## Product / Process Change Notification (PCN)

**PCN #:** PCN\_WL-SMRW\_20190607  
**Affected Series:** WL-SMRW rectangular; 156120xx75000

**PCN Date:** March 25, 2019  
**Effective Date:** June 07, 2019

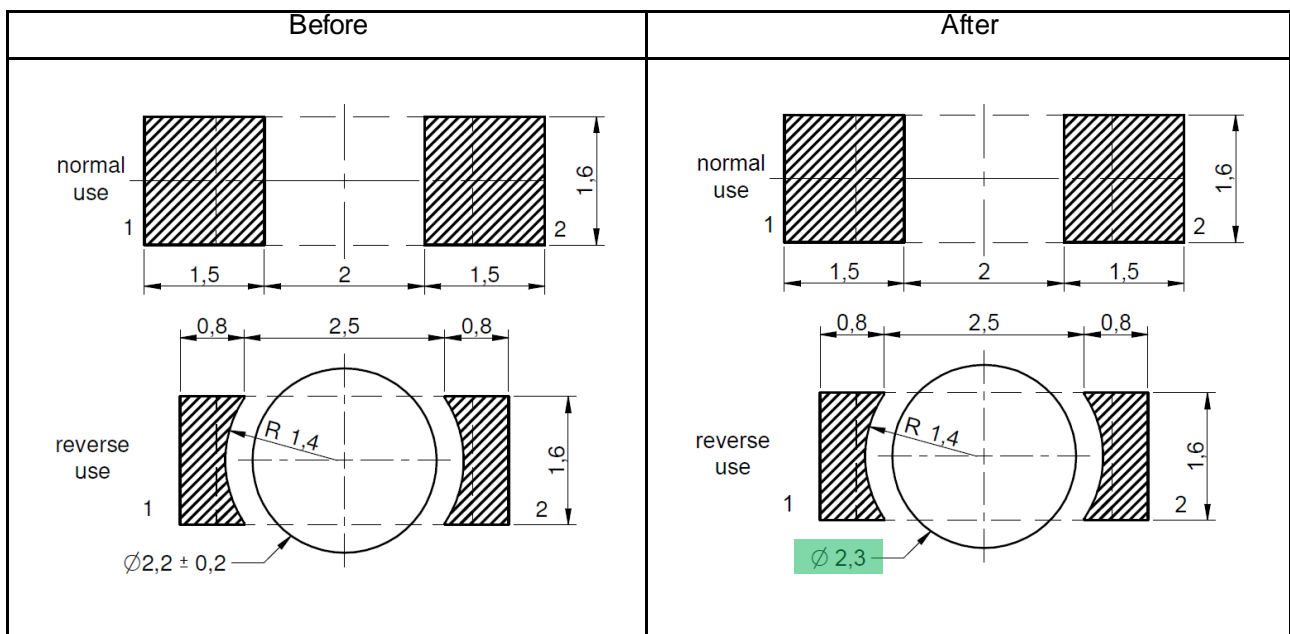
As a datasheet information amendment, Würth Elektronik eiSos updated the recommended land pattern for the product group WL-SMRW 1206 rectangular.

There will be no change in form, fit, function, quality or reliability of the product, just only a correction to the datasheet
